STAFF REPORT: 06/11/2025 MEETING
ADDRESS: 141 W. BOSTON BOULEVARD
APPLICATION NO: HDC2025-00238
VIOLATION NO: 1023

SCOPE: REMOVE CLAY TILE ROOF AND REPLACE WITH ASPHALT ROOF (WORK STARTED WITHOUT APPROVAL)

141 W. Boston. Photo taken by staff on 5/23/2025. Note the tarp covering the area of roof tiles that were removed without HDC approval.

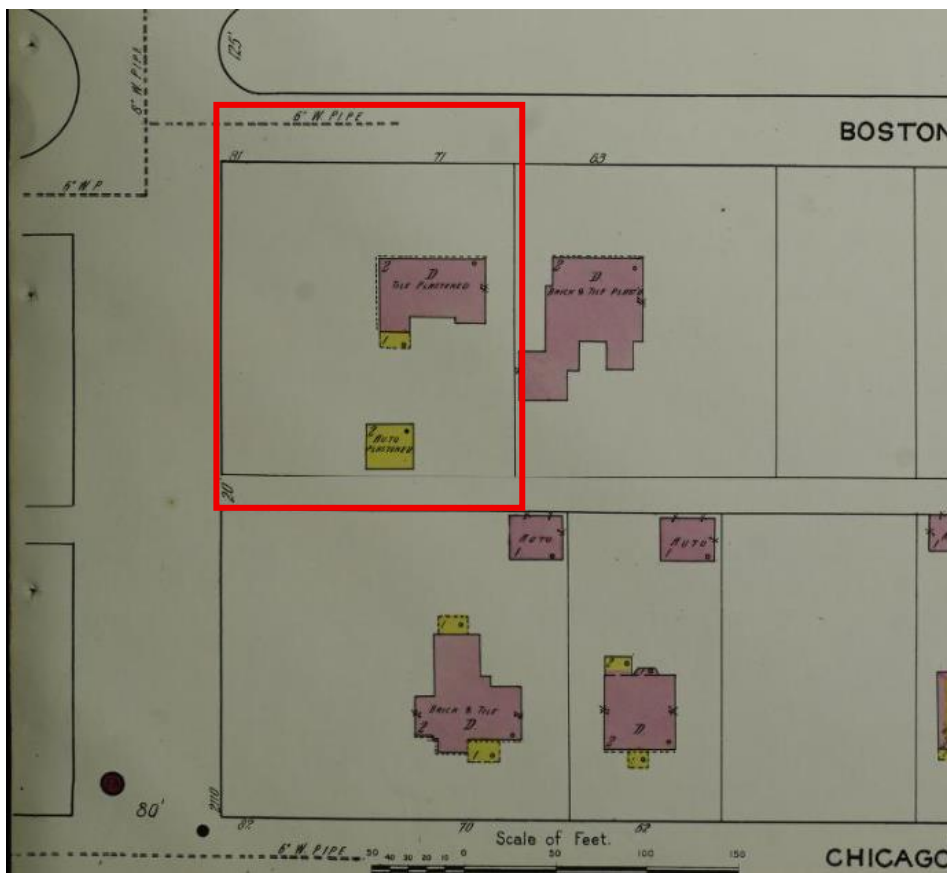
141 W. Boston. Photo taken by staff on 5/23/2025. Note the tarp covering the area of roof tiles that were removed without HDC approval.

Photo by applicant. Showing area of roof repair at front paired dormers. Note small area of asphalt roofing

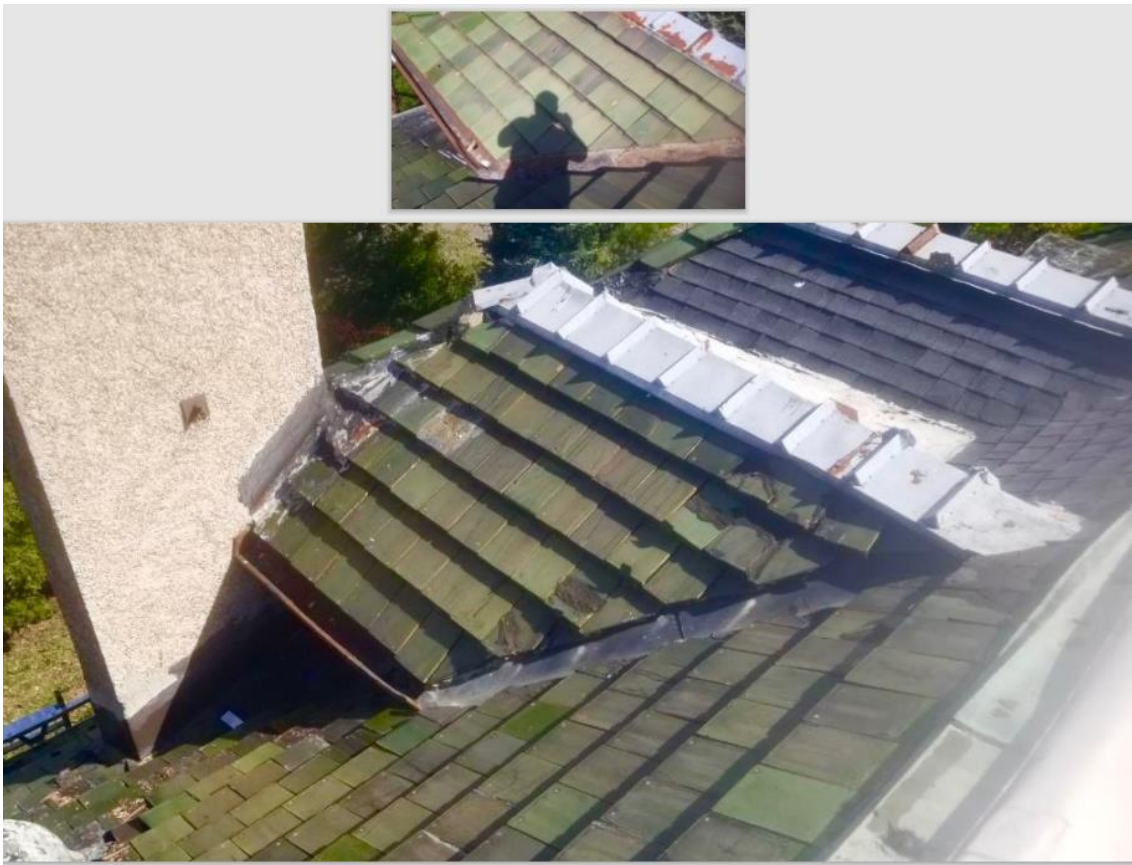
- A full photographic documentation can often suffice in re: to demonstrating the condition/level of deterioration of an historic roof. However, as the roof was not fully documented before the unapproved clay tile removal was undertaken, staff is left to rely on the few submitted photos to understand the condition of the entirety of the historic clay tile roof. It is not clear to staff that the few submitted photos clearly indicate that remaining tiles could not have been salvaged for reinstallation.
